Plan Change Request

➤ Specify the approved civil plans affected: C5-101, C5-201, C5-202, C5-201, C6-101, C6-201

Project:
**WSF Gold Gate
 Redevelopment**
 Civil Construction
 Permit

DWG. **C5-101**
 22 OF 27

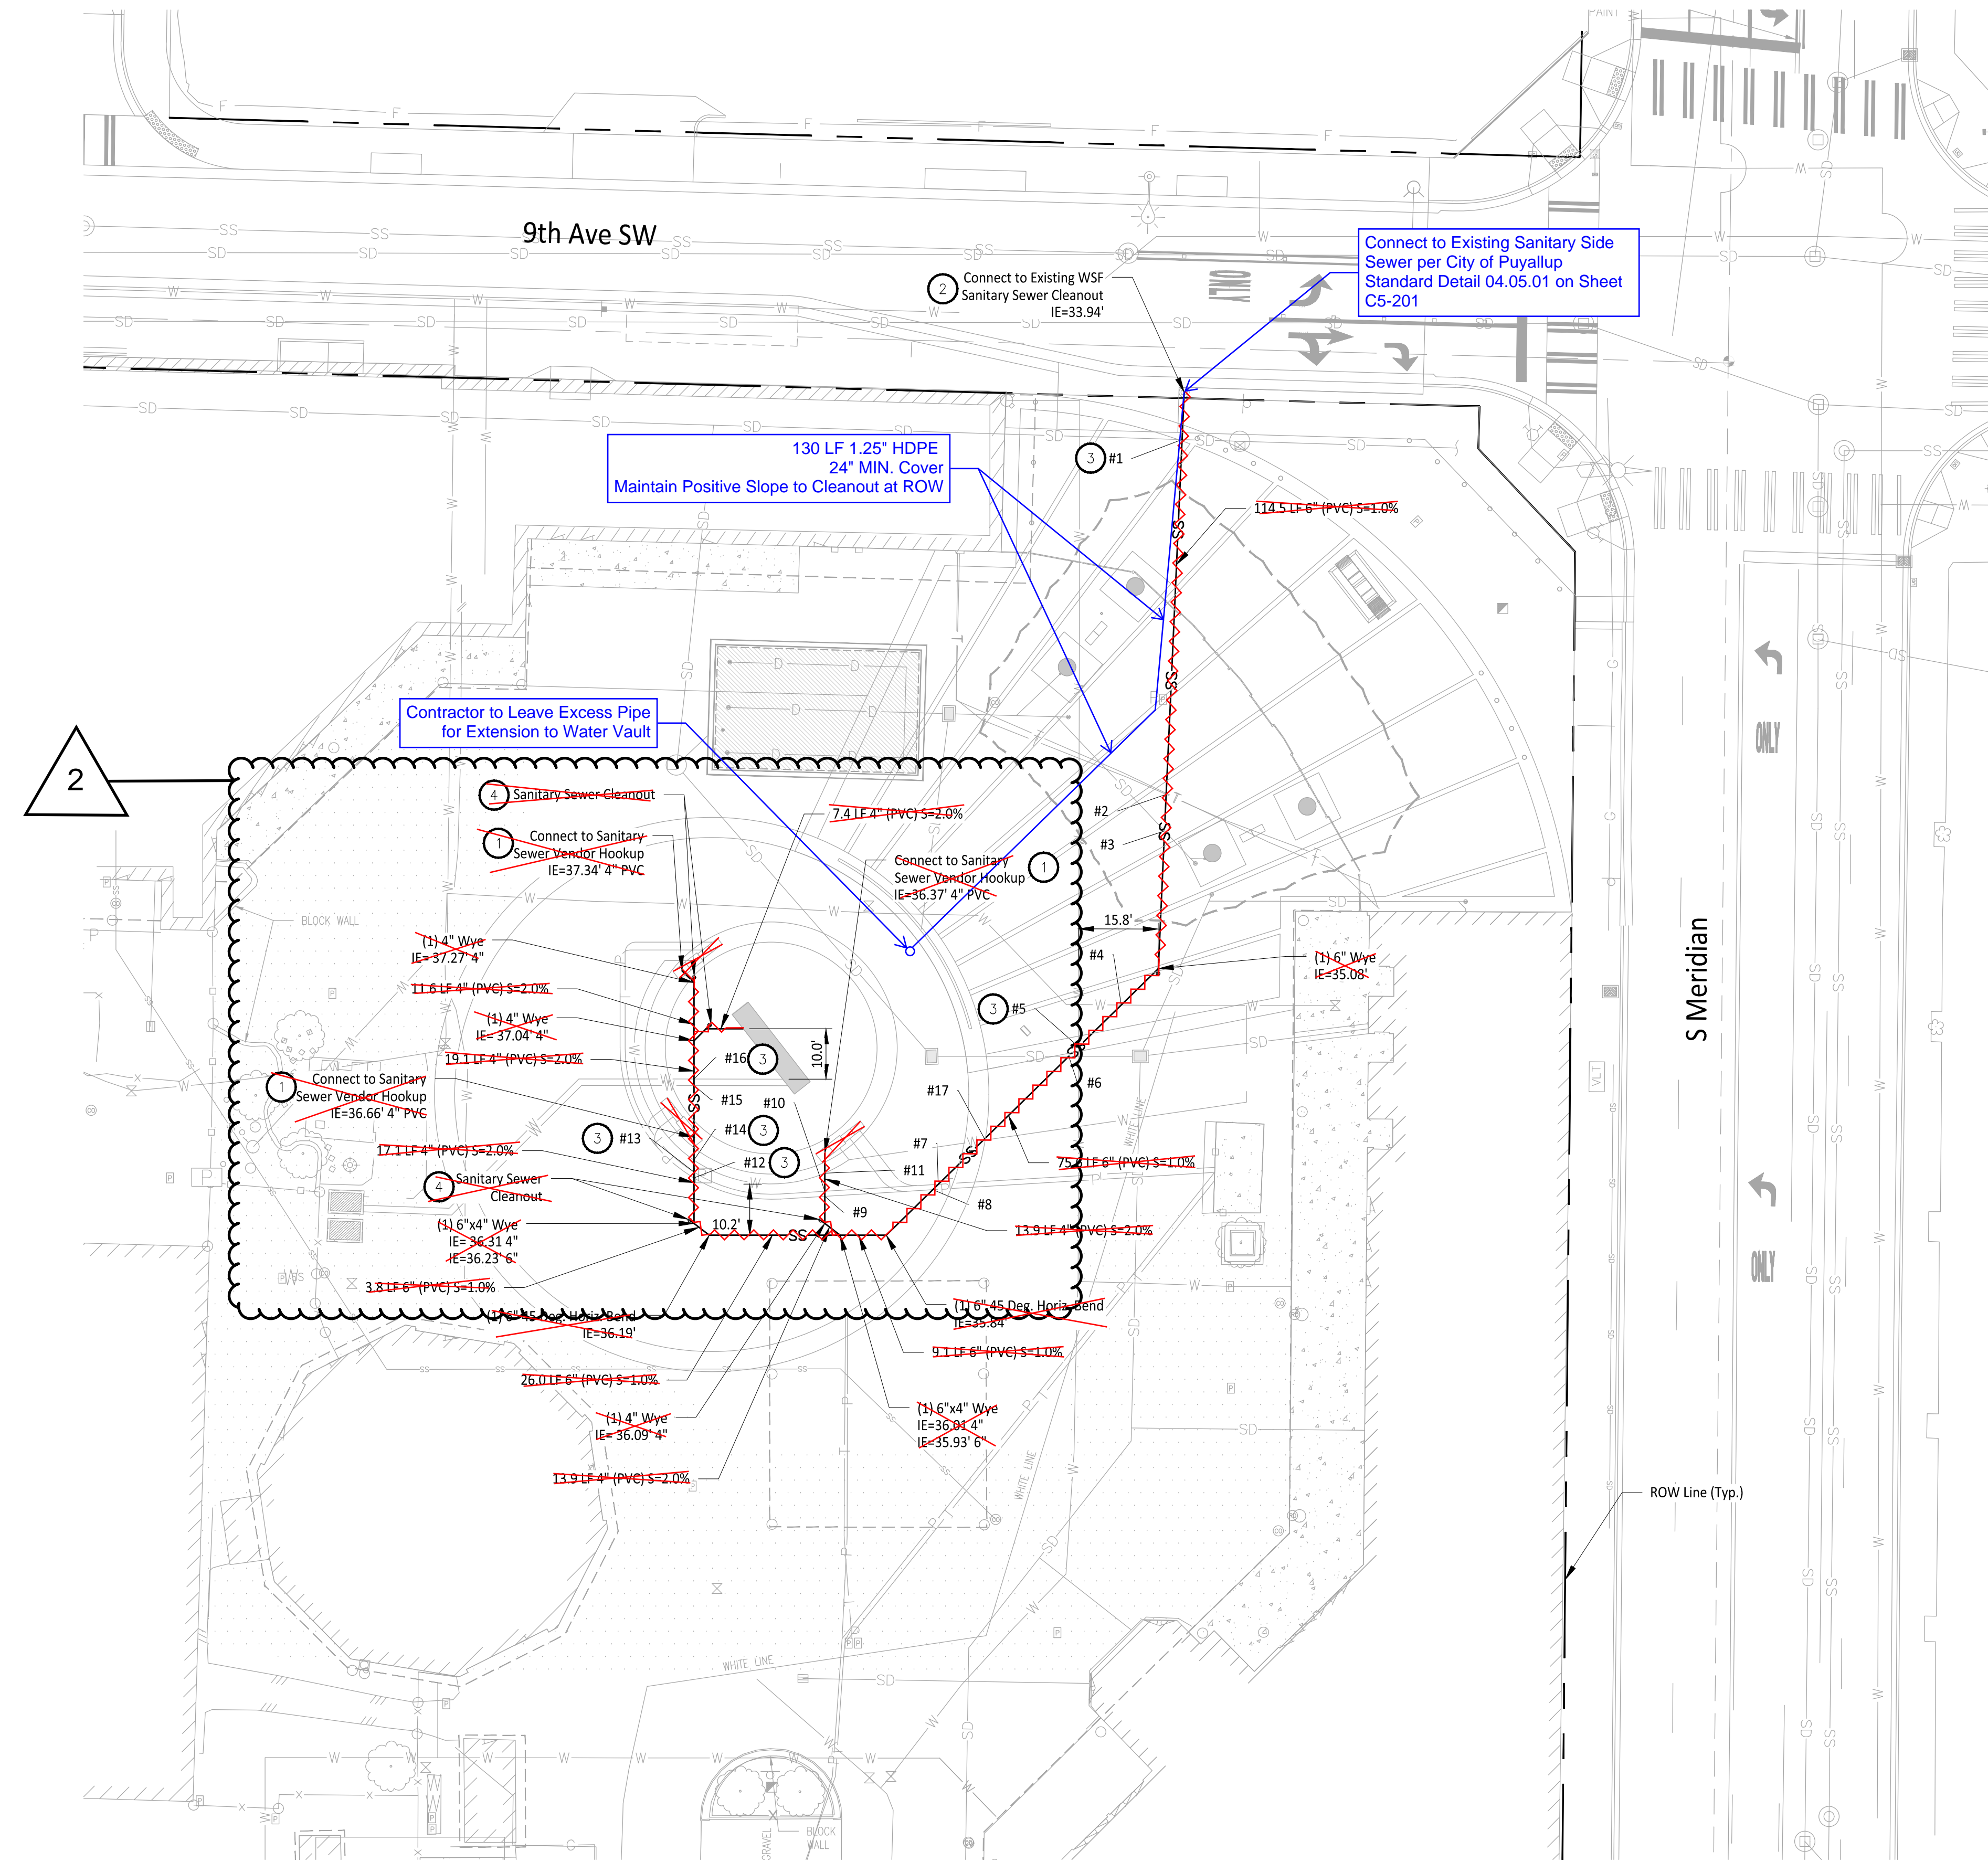
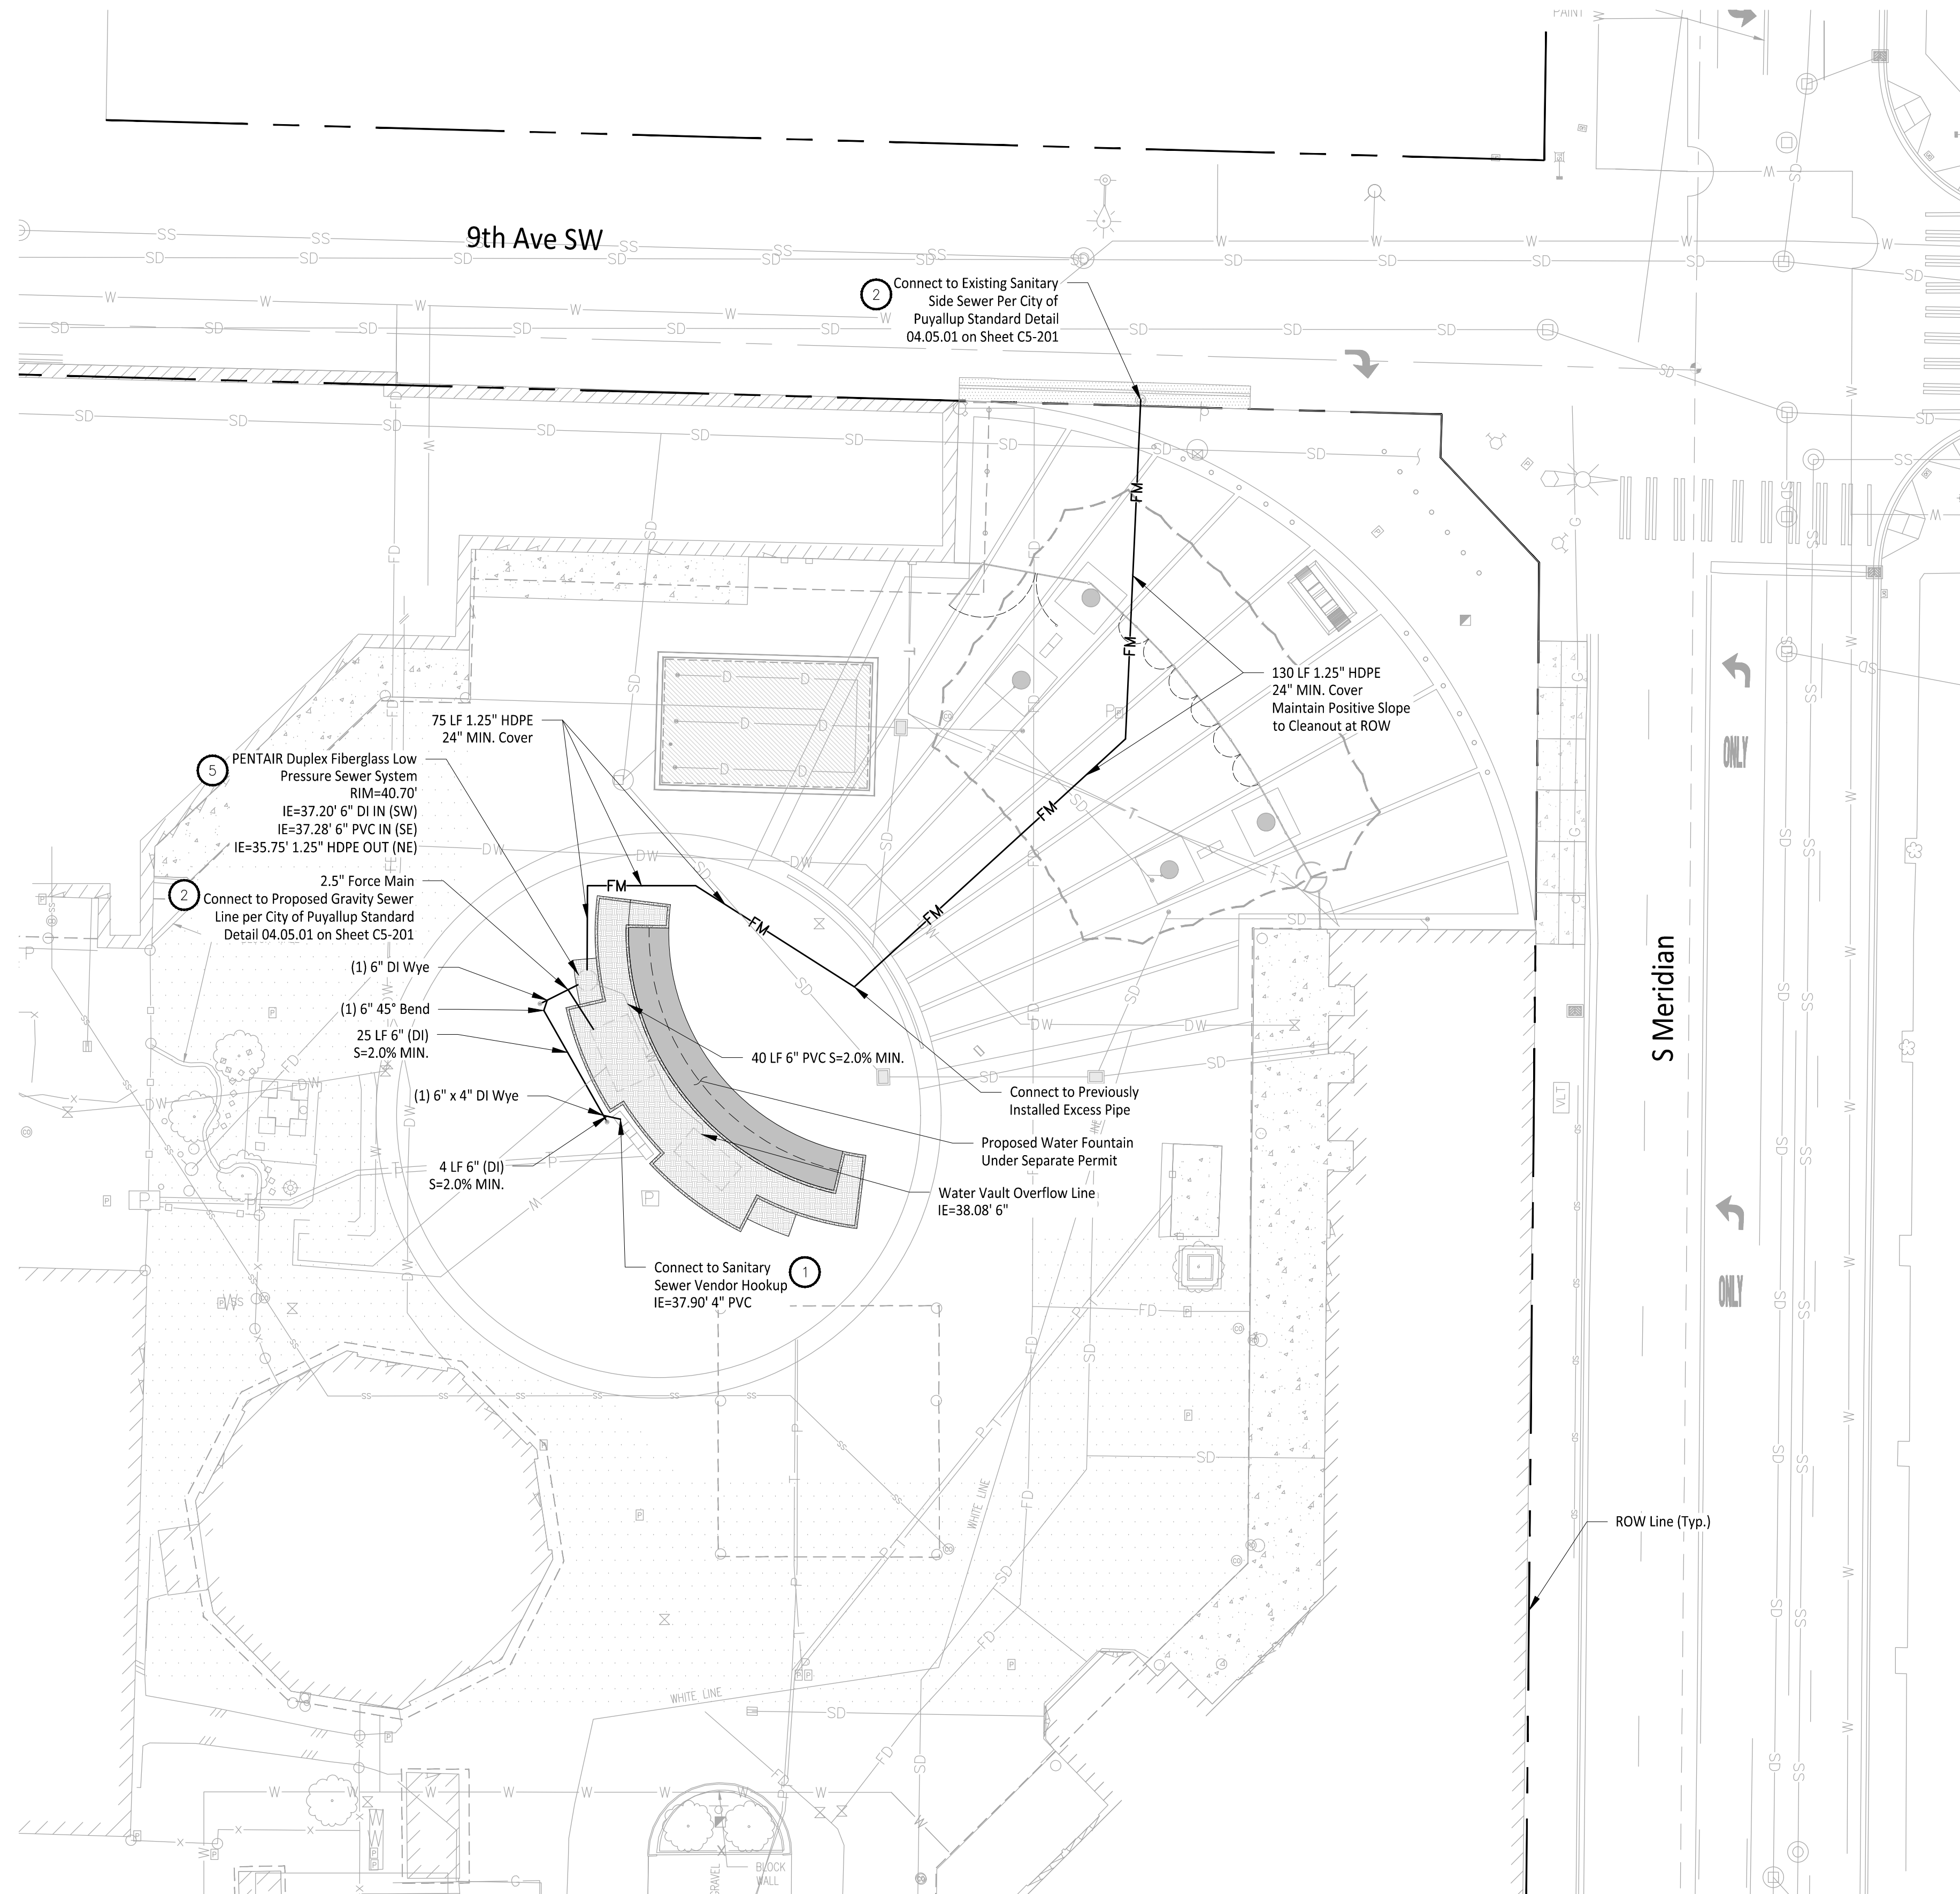
A new fountain structure and 4 vendor hookups (Sewer, Water, Power, Comm.) will be installed. The fountain will be permitted under a separate permit. A water connection will be made from the previously installed water stub to the proposed fountain mechanical vault. In addition, a new pre-built sewer lift station will be installed that will pump the fountain overflow/flushed water and vendor hookup discharge to a previously installed force main that connects out to a side sewer along 9th Ave SW.

- 1 Domestic Water Service and Sanitary Sewer Vendor Hook Ups to be Installed per Detail A on Sheet C5-201
- 2 Install Commercial Side Sewer Connection per City of Puyallup Standard Detail 04.03.04 on Sheet C4-201.
- 3 Contractor to install foam pad between pipe crossings with less than 18" of vertical clearance. The pad shall be O.D. x O.D. x 2.5 inches thick minimum or as required to protect the pipes. Above O.D. is equal to the outside diameter of the larger pipe. The pad shall be a polyethylene foam plank (Dow Plastics Ethafoam 220), or approved equal. See Detail B on Sheet C5-201 for detail, and Sheet C6-201 for City of Puyallup Utility Crossing Standard Details.
- 4 Install Cleanout per City of Puyallup Standard Detail 04.03.04 on Sheet C4-201.
- 5 Install PENTAIR Duplex fiberglass Low Pressure Sewer System per specifications on Sheets C5-201 and C5-202.
